# CAUI-4 Ad hoc

Ryan Latchman, Mindspeed

Figure 83E-15—Example module stressed input test

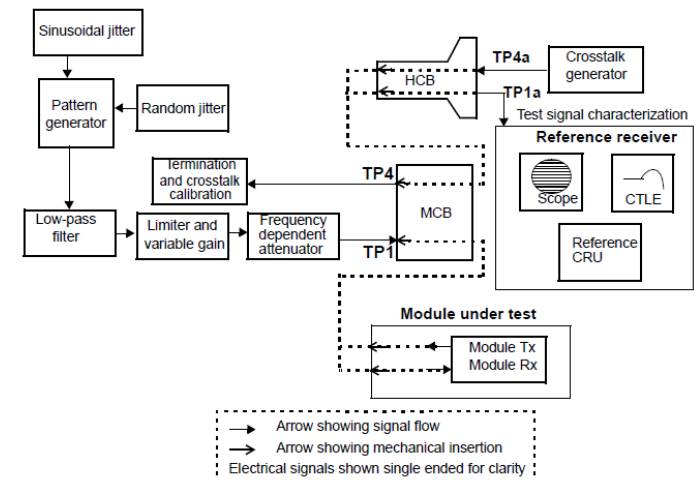
- Low loss test: remove frequency dependent attenuator
  - Total loss between limiter and TP1a is the mated MCB / HCB loss
    - 2.86 to 4.6dB loss at 12.89GHz
    - Keep same EH/EW targets
- Host output compliance test:
  - 2) Apply respective reference receiver CTLE to captured signal. Any single CTLE setting which meets both eye width and eye height requirements is acceptable for the module compliance . For host compliance, the CTLE peaking in the reference receiver shall be set at one of three values. These are: a) the recommended CTLE peaking value provided by the host, b) the value 1 dB higher if present in Table 83E-2 and the value 1 dB lower if present in Table 83E-2. Any of the three CTLE settings that meets both the eye width and eye height defined in Table 83E-1 is acceptable.
- Next: mechanism for host to provide value
